model is the one I received on 23/5/12, it could be out of date, so maybe the design has changed significantly? I moved the open half of the castle to close against the other half. Please send me a STEP file of the new design, when appropriate

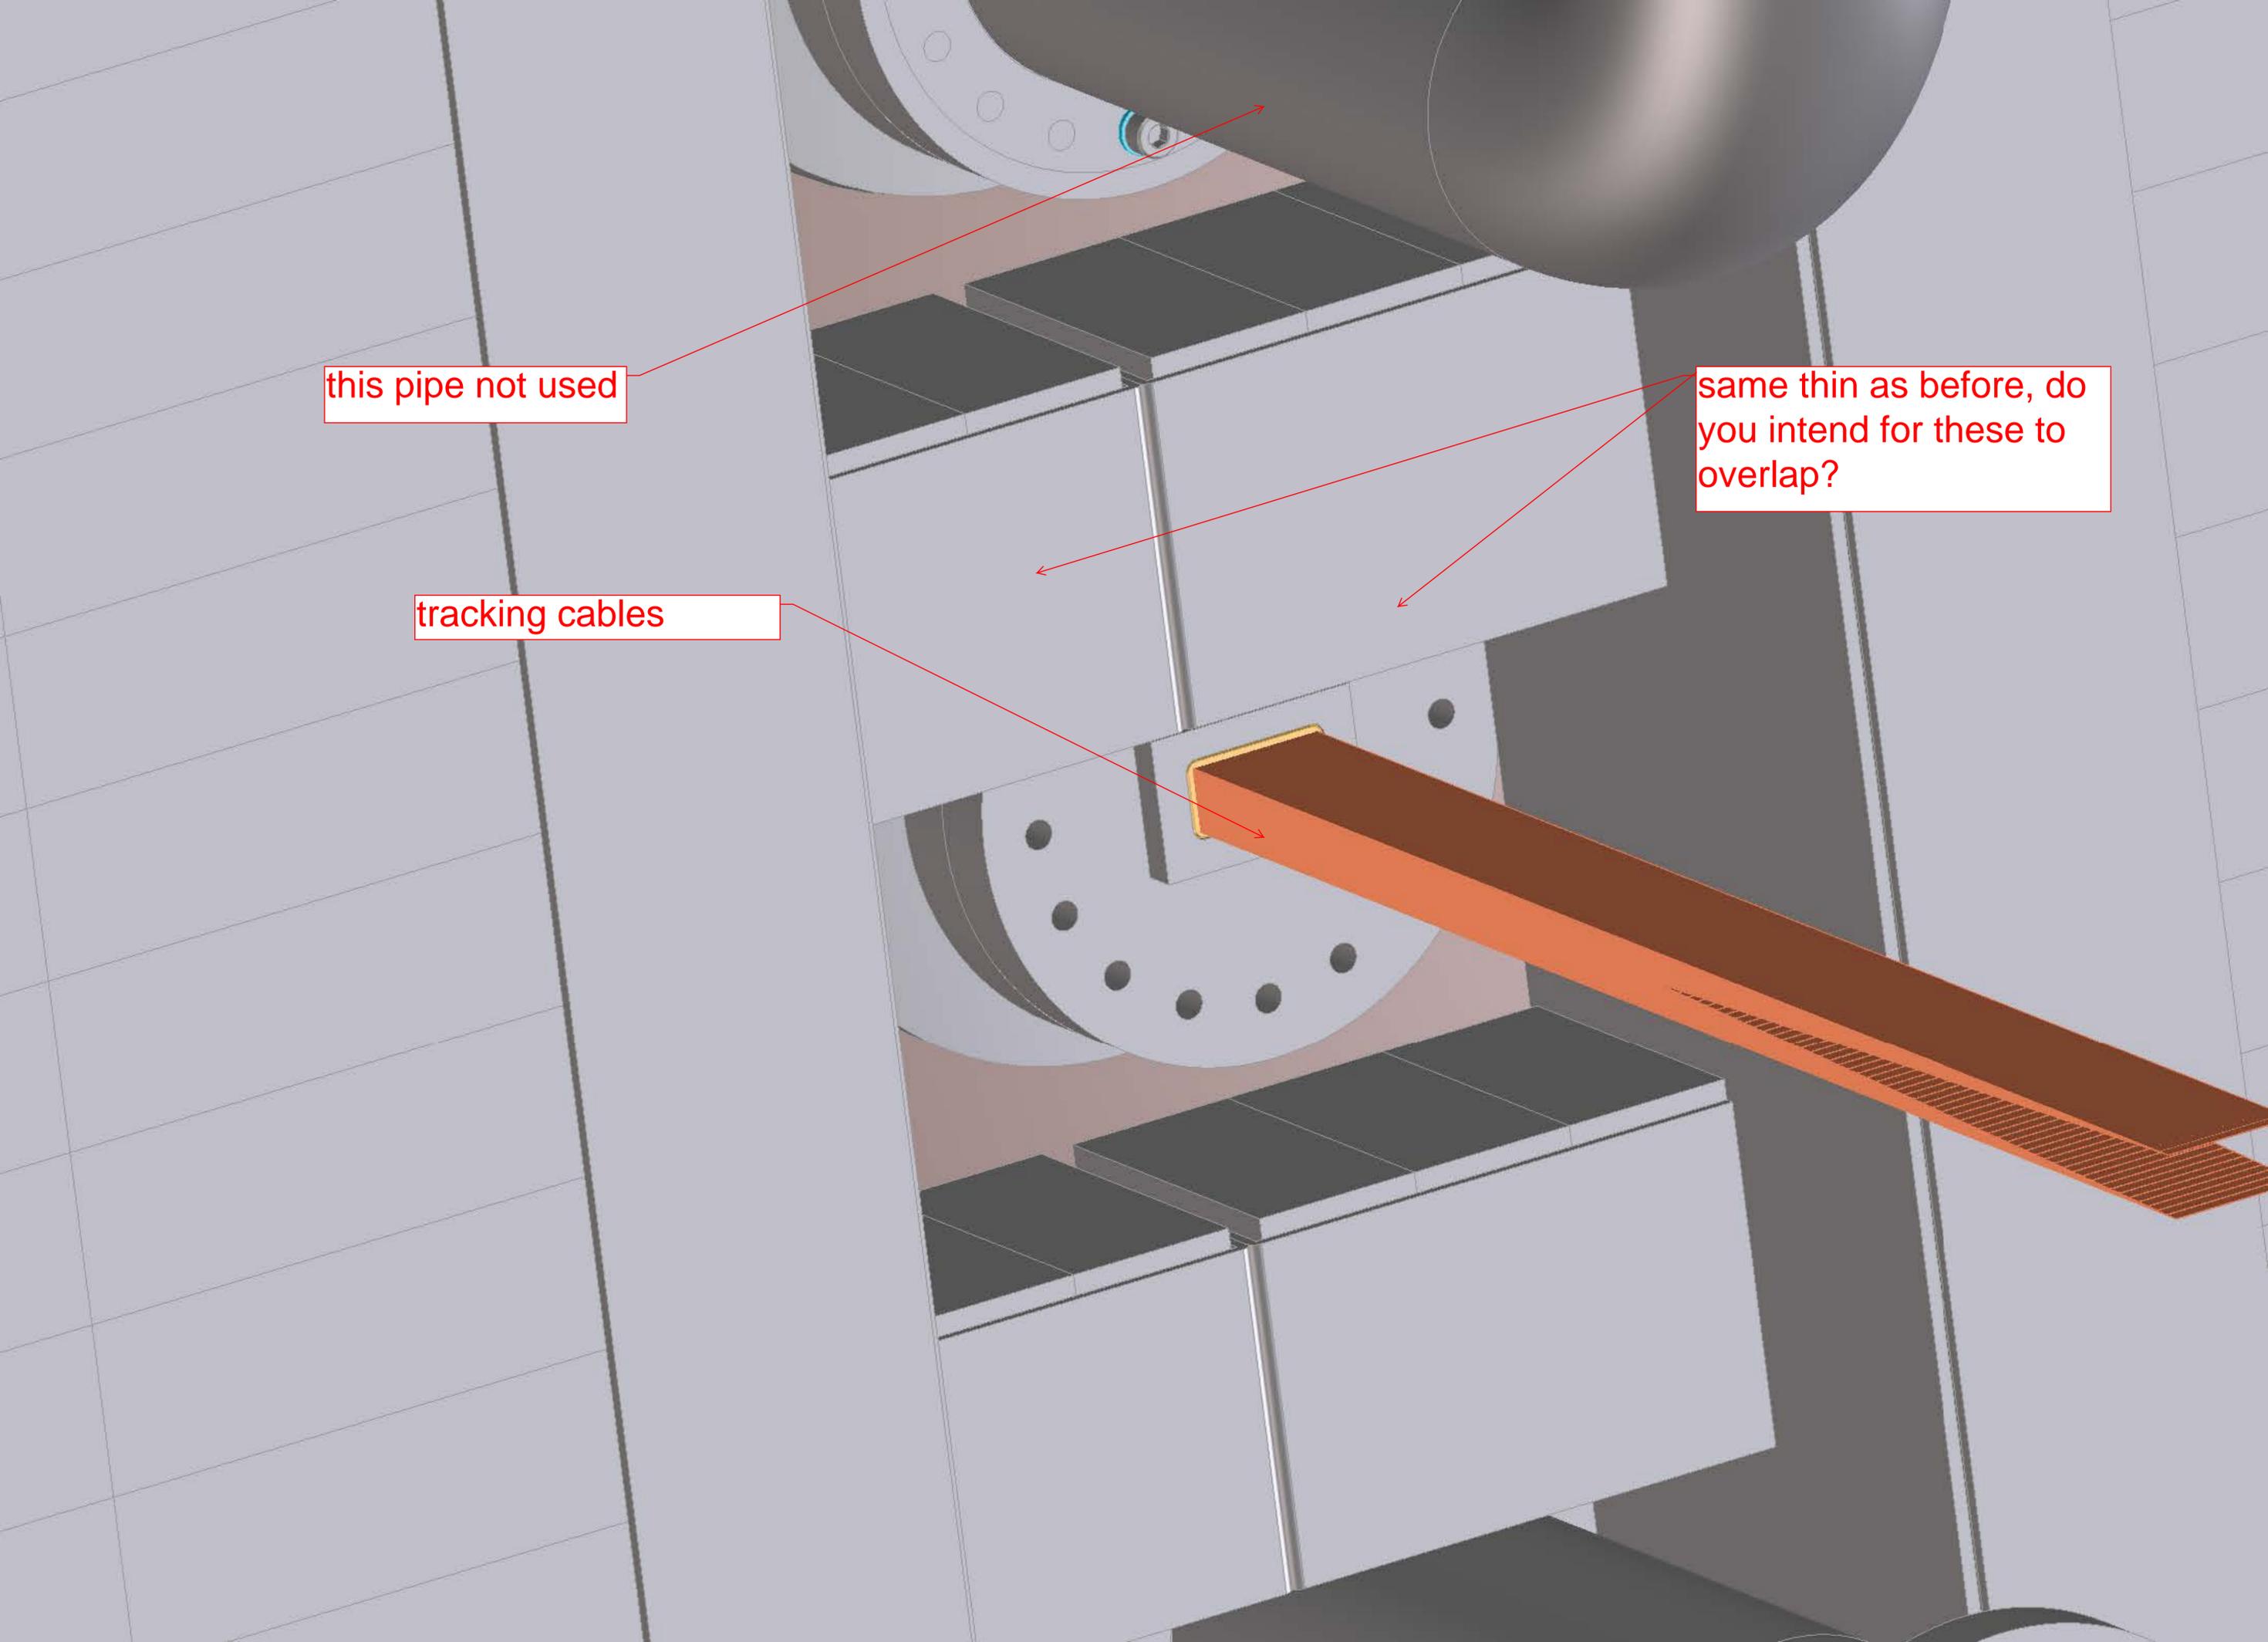
10 cm here, do you mean to have 20 cm?

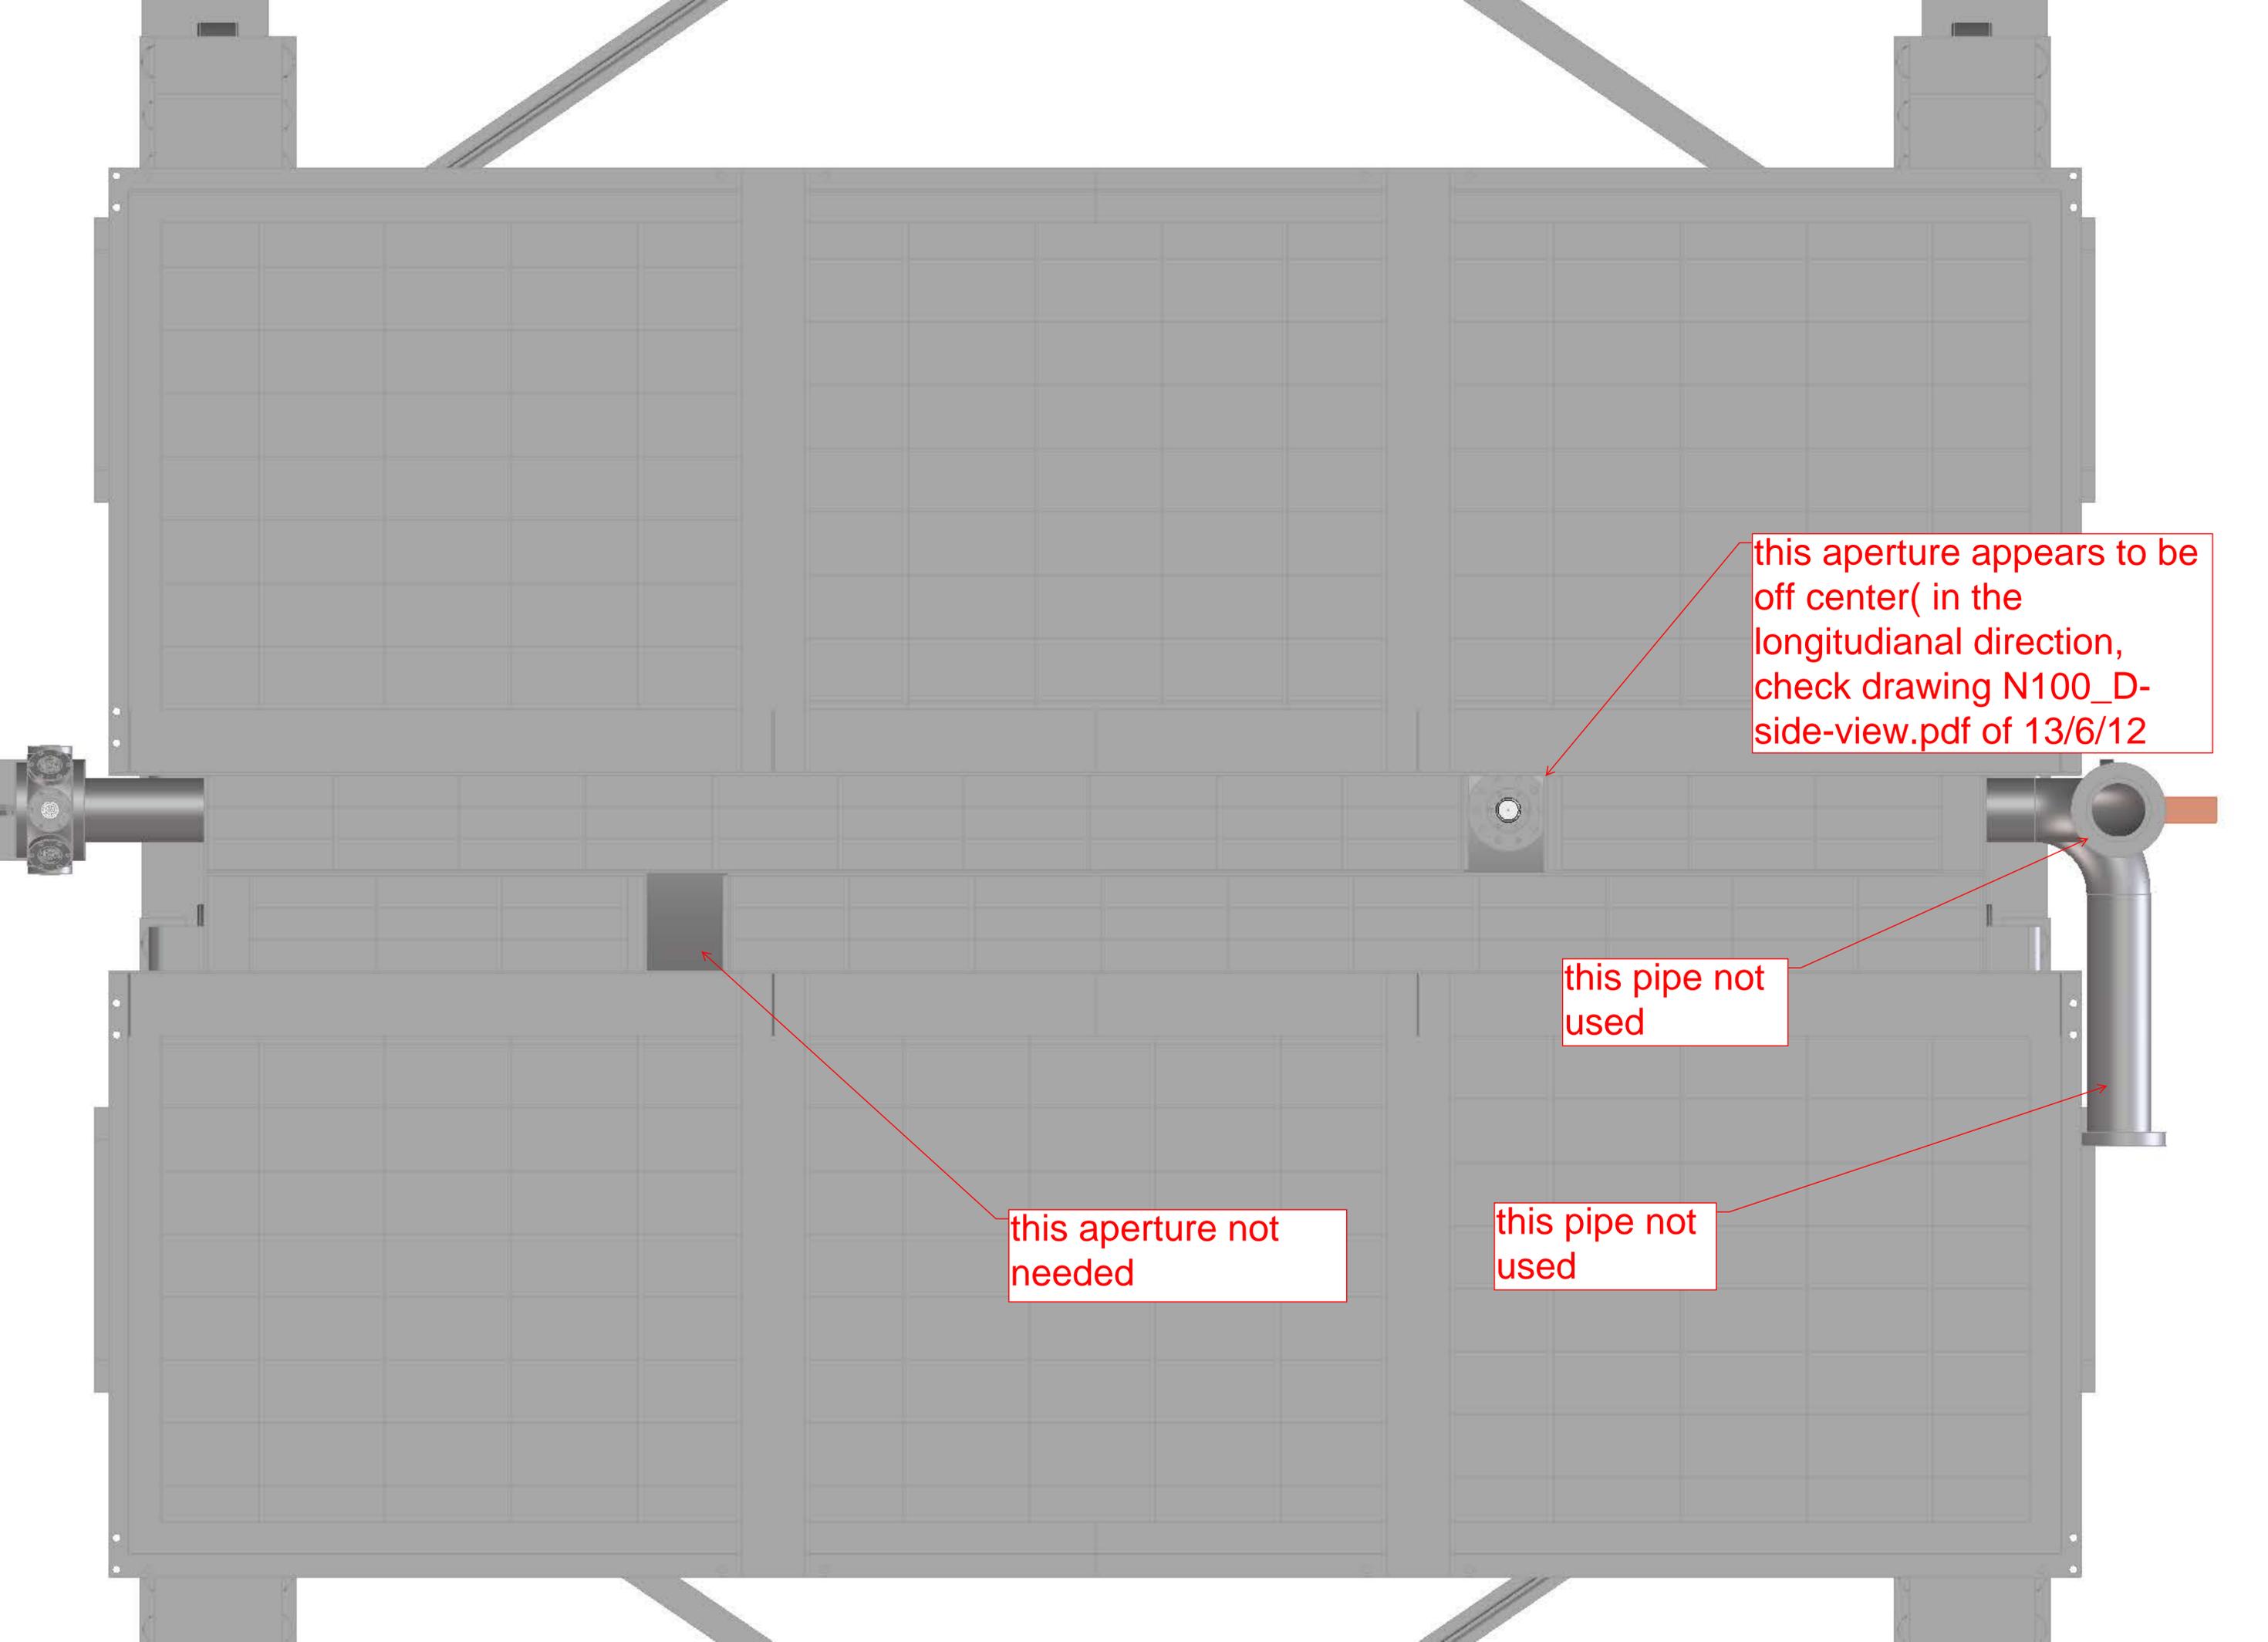
15 cm here, I think this should be 11-12 cm

this pipe not used

tracking cables

same thin as before, do you intend for these to overlap?

this aperture appears to be off center( in the longitudinal direction, check drawing N100\_D-side-view.pdf of 13/6/12

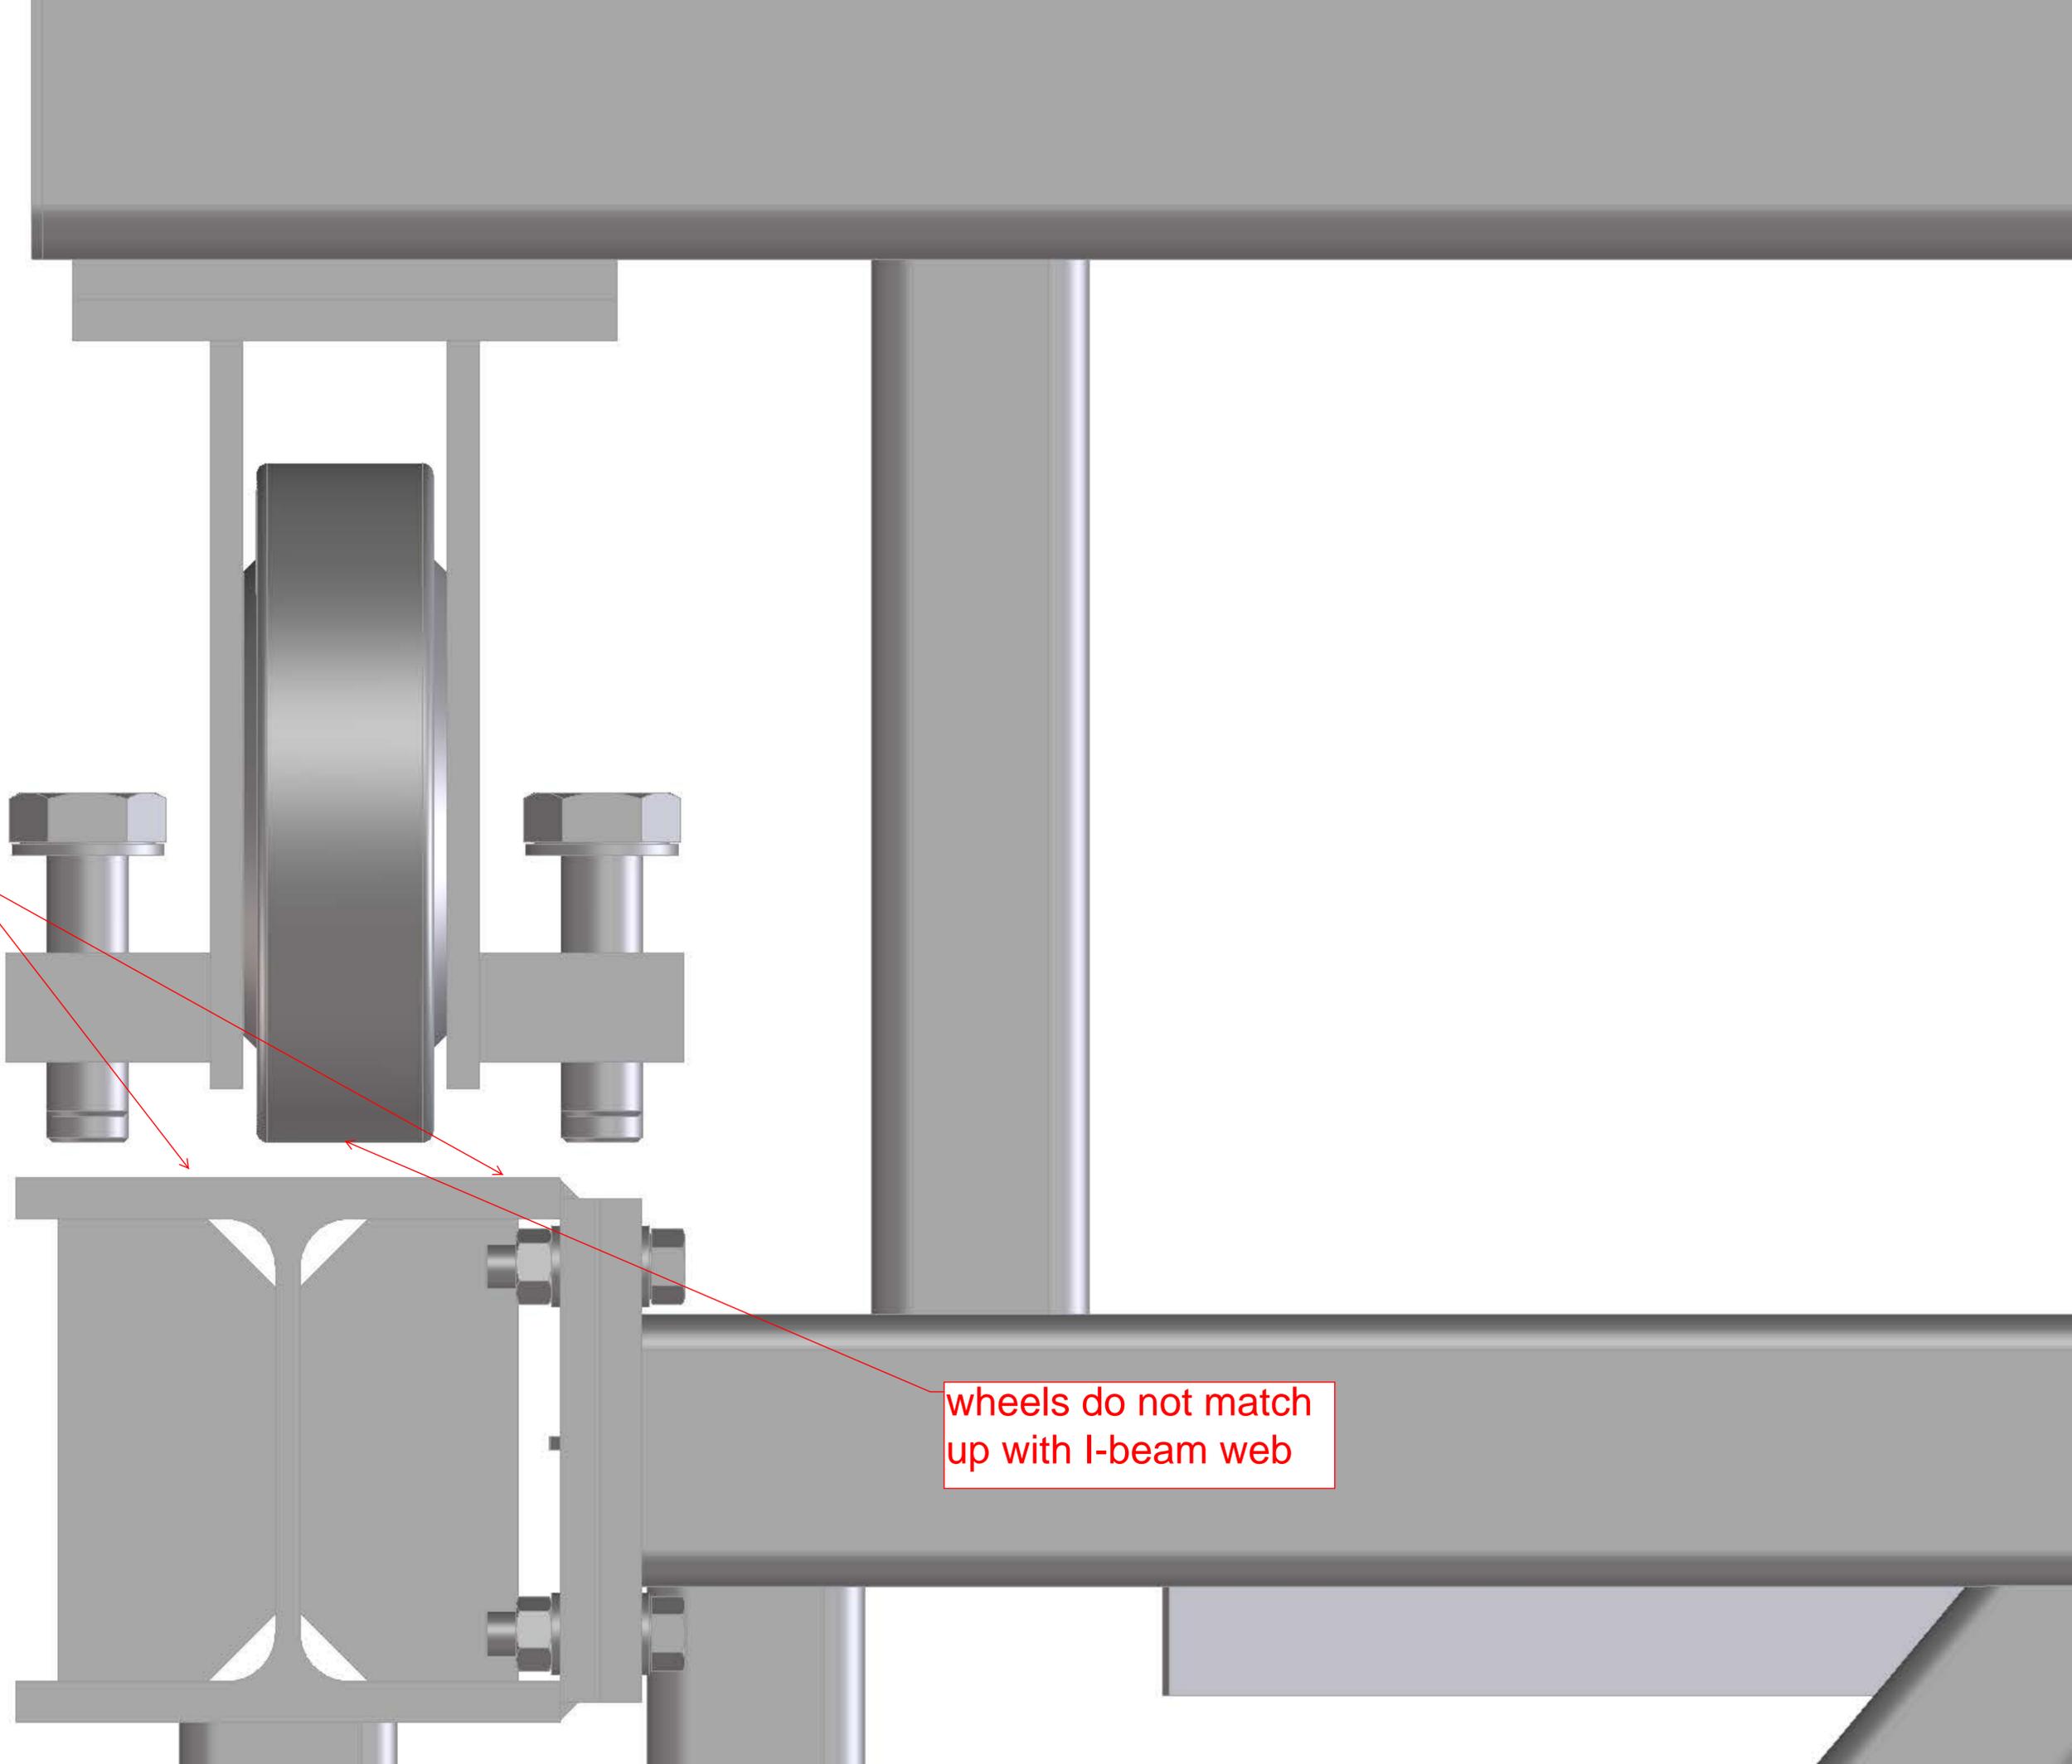
this pipe not used

this pipe not used

this aperture not needed

are there  
wheel guides  
here?

wheels do not match  
up with I-beam web

this pipe not used
